Response-to-Comments Table

Application for Permission Under Section 16 of the Town Planning Ordinance (Cap.131) Proposed Comprehensive Development including Flat, Retail and Community Facilities and Minor relaxation of Plot Ratio and Building Height Restrictions in “Comprehensive Development Area” Zone at Various Lots in S.D. 4 and Adjoining Government Land, Kau Wa Keng, Kwai Chung)

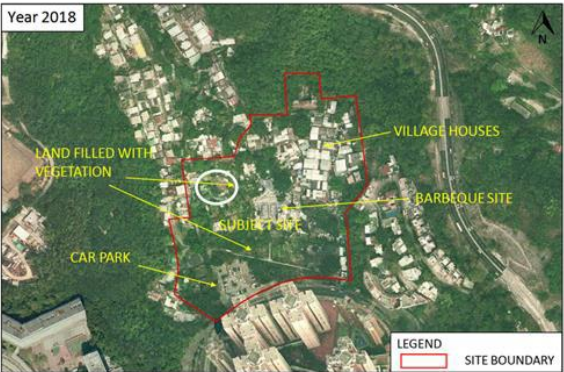
No.	Comments	Responses
	<p><u>Specific Comments for the SPS</u></p> <p>9. <u>Figure no. 7c of the SPS</u></p>	<ul style="list-style-type: none"> • Preserve and restore the main architectural external features and interior spaces of the historic buildings; • Remove later additions, structurally not safe or any illegal structures from the buildings which are of detrimental effect to the architectural significance of the historic buildings; • Design surrounding open space and streets to be compatible with the historical ambience of the buildings to enhance compatibility and integration; • Introduce adaptive uses of the historic buildings, for example exhibition halls, visitor centres, local convenience stores, cafeteria etc., integrating the buildings’ historical significance into everyday life of the future residents and visitors; and • Ensure public access to encourage visits and uses from residents and visitors for visual appreciation and full immersion in the historical ambience. <p>According to the proposed conservation strategy, all historic buildings will be conserved holistically upon the completion of the remaining phases development.</p> <p>Upon approval of this S16 Planning Application (including the proposed conservation strategy being part of it) by the TPB, should any parties consider alternative approaches to conserve these historic building, a separate S16 planning application is required for TPB and AMO’s agreement to ensure the proposed developments are considered holistically in relation to the for area's historical assets.</p>
